**UNITED STATES DEPARTMENT OF COMMERCE**  
**Patent and Trademark Office**

APPLICATION NO.	FILING DATE	FIRST NAMED INVENTOR	ATTORNEY DOCKET NO.
09/556,829	04/21/00	KUHLMANN-WILSDORF	D 10582-0002-2

# Office Action Summary

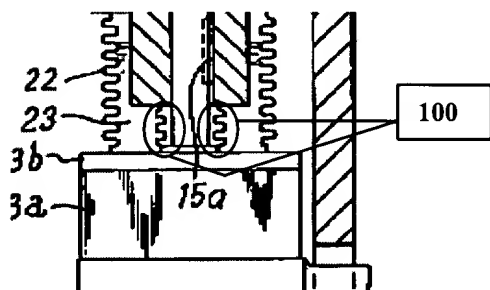
Dobbing et al. clearly teaches the construction of an electrical brush holder for applying a mechanical force to an electrical brush (13), comprising:

a first wall (22) fastened to a current conducting element (16a);

a second wall (13b) configured to be fastened to the brush;

a sidewall (21) lengthwise extending in an axis direction of the brush and cooperating with the first and second walls to form a volume defined by the first wall, the second wall and the sidewall; and

a fluidic medium (23) contained in the volume and configured to apply a pressure to the brush via the second plate.

13. With regards to claim 3, Dobbing et al. discloses an electrical brush holder wherein said fluidic medium comprises a gas (100, added by the examiner for convenience) and a liquid metal (23) in pressure-transmitting contact with each other via at least one flexible membrane (21).
